15 August 2018

**MODIFICATION OF CONSENT (SECTION 4.55(1A)) – MOD 1  
SSD DA 17\_8388 – MACQUARIE UNIVERSITY ARTS PRECINCT PROJECT (MUAPP)  
MACQUARIE UNIVERSITY**

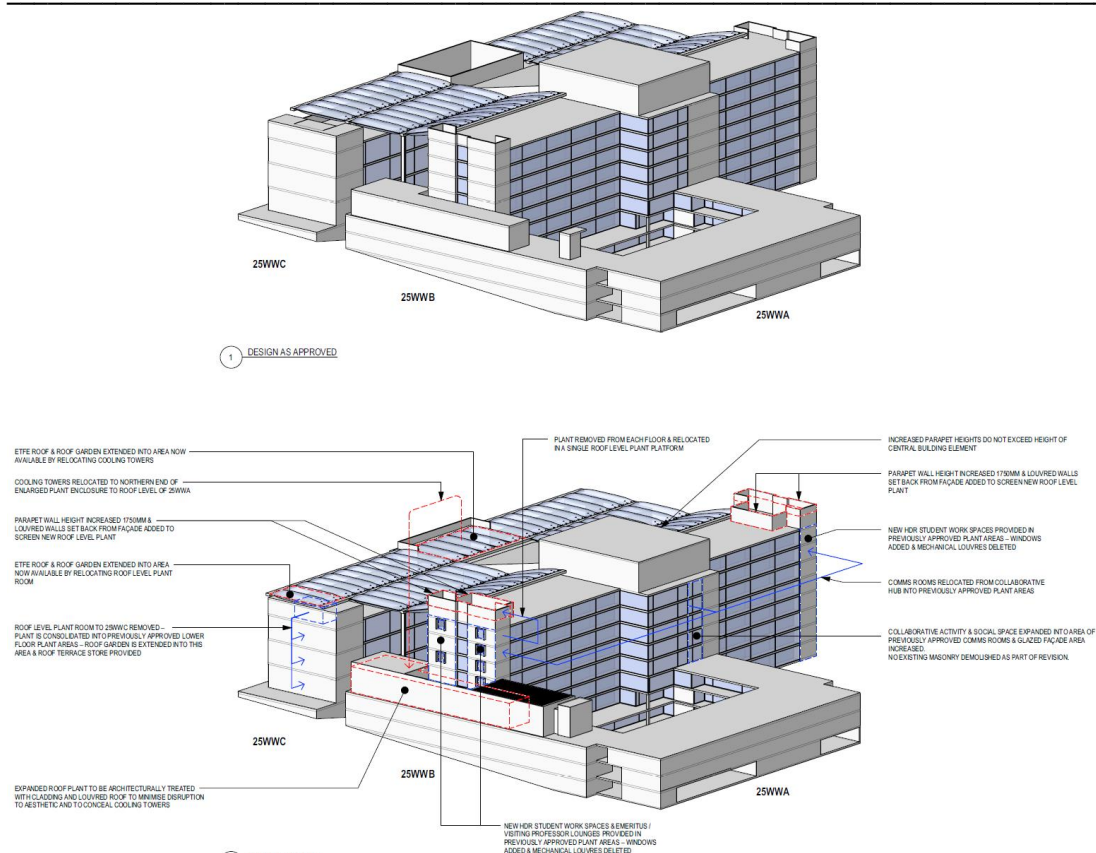
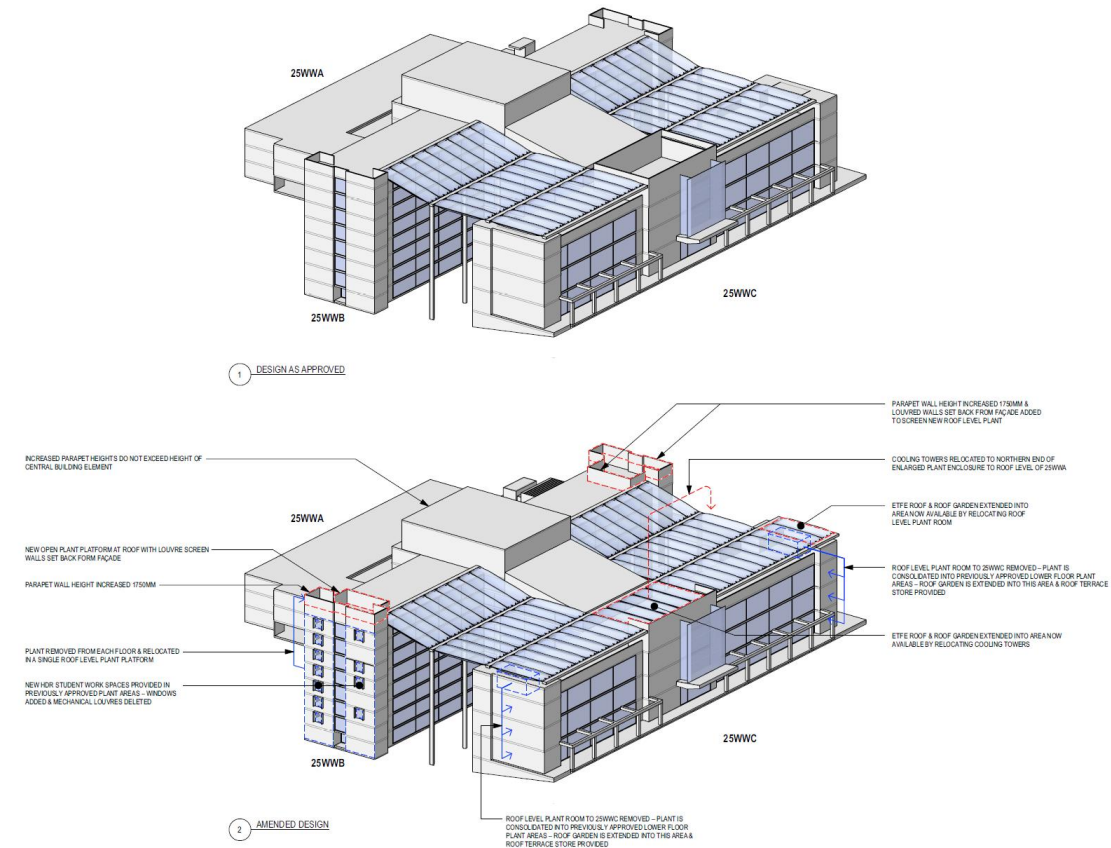
In implementing the centralised mechanical services design philosophy across the three buildings, in general terms the following results:

- deletion of plant rooms on the eastern and western extremities of each floor of 25WWB and transfer of plant to consolidated rooftop plant areas at the eastern and western extremities of the building;
- Replanning of newly freed-up space on each floor of 25WWB for a variety of academic, teaching, learning, and functional / ancillary spaces and purposes;
- Relocation of plant areas on the 25WWC rooftop to lower level plant room locations in 25WWC and to an enlarged consolidated plant area on the rooftop of the eastern wing of 25WWA directly to the east of 25WWB; and
- Expansion of the useable rooftop terrace area of 25WWC arising from the newly freed-up space.

The main changes to the external appearance and bulk or scale of the approved building (as circled in red on the render of the proposed above) are generally confined to:

- The extension of the masonry façades at the eastern and western ends of 25WWB by an additional 1750mm in height, whilst remaining within the previously approved maximum building height;
- The extension of plant area atop 25WWA at its eastern elevation directly adjacent to 25WWB; and
- Extension of the lift overrun in the same general location.
